APPLICATION NO.	FILING DATE	FIRST NAMED INVENTOR	ATTORNEY DOCKET NO.	CONFIRMATION NO.
10/573,543	03/27/2006	Danut Bogdan	2003P13768	7334
	7590 05/18/200 ENBERG STEMER L	•	EXAMINER	
P O BOX 2480		<del></del>	CRUZ, LESLIE PILAR	
HOLLYWOOD, FL 33022-2480			ART UNIT	PAPER NUMBER
			2826	
•			MAIL DATE	DELIVERY MODE
			05/18/2007	PAPER

#### **DETAILED ACTION**

The amendment filed on 21 February 2007 in response to the Office Action mailed on 17 November 2006 has been entered. The present Office Action is made with all the suggested amendments being fully considered. Accordingly, pending in this Office Action are claims 10-12 and 14-22.

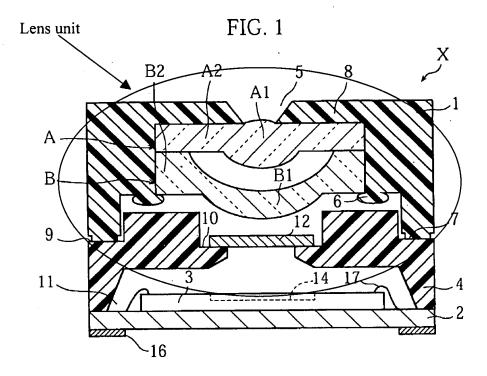
With respect to claim 10, Figs. 1 and 4 of Fujimoto discloses an optical module comprising: a circuit carrier [2]; a semiconductor element disposed in a housing [4] disposed on the circuit carrier, the housing of the semiconductor element, at least in sections thereof, having a support [9] formed thereon; and a lens unit [see figure below] configured for projecting

electromagnetic radiation onto the semiconductor element, said lens including a base lens [1]; wherein the semiconductor element and the lens unit are formed in two parts, and the lens unit is supported on the base lens and the base lens [bottom of 1] is supported on and indirect contact with the support formed on the housing of the semiconductor element.
